ITEM NO: 6.3 REPORT NUMBER: 176/24

DEVELOPMENT NO.:	24005807		
APPLICANT:	Steven Huang		
ADDRESS:	56 PARINGA AV SOMERTON PARK SA 5044		
NATURE OF DEVELOPMENT:	The construction of a new manufacturing facility (light		
	industry), including ancillary offices, landscaping and parking.		
ZONING INFORMATION:	Zones:		
	Employment		
	Overlays:		
	Airport Building Heights (Regulated)		
	Building Near Airfields		
	Prescribed Wells Area		
	Regulated and Significant Tree		
	Traffic Generating Development		
LODGEMENT DATE:	1 Apr 2024		
RELEVANT AUTHORITY:	Assessment panel at City of Holdfast Bay		
PLANNING & DESIGN CODE VERSION:	P&D Code (in effect) Version 2024.5 14/03/2024		
CATEGORY OF DEVELOPMENT:	Code Assessed - Performance Assessed		
NOTIFICATION:	Yes		
RECOMMENDING OFFICER:	Alexander Stamatopoulos		
	Development Planner		
REFERRALS STATUTORY:	Nil		
REFERRALS NON-STATUTORY:	Nil

Above: 30 Paringa Avenue

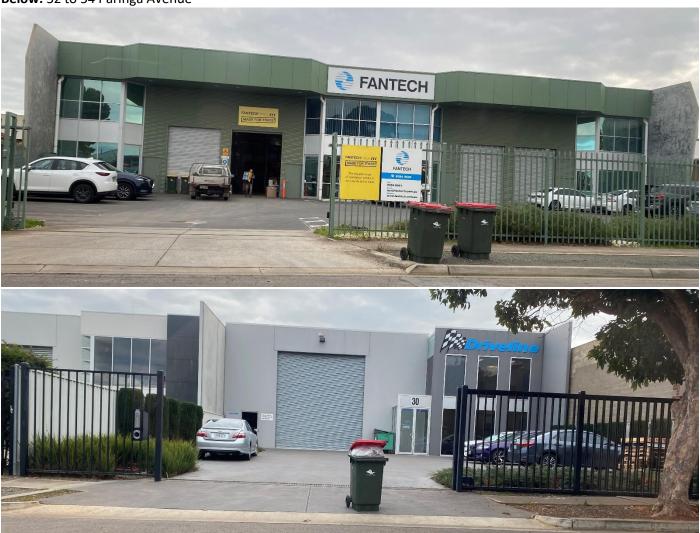
Below are a series of photos of buildings with near identical built forms to the development. These buildings are located on Paringa Avenue to the west of the site.

The proposed development contains an appropriate built form that is consistent with the established character of buildings in the Employment Zone satisfying PO 2.2.
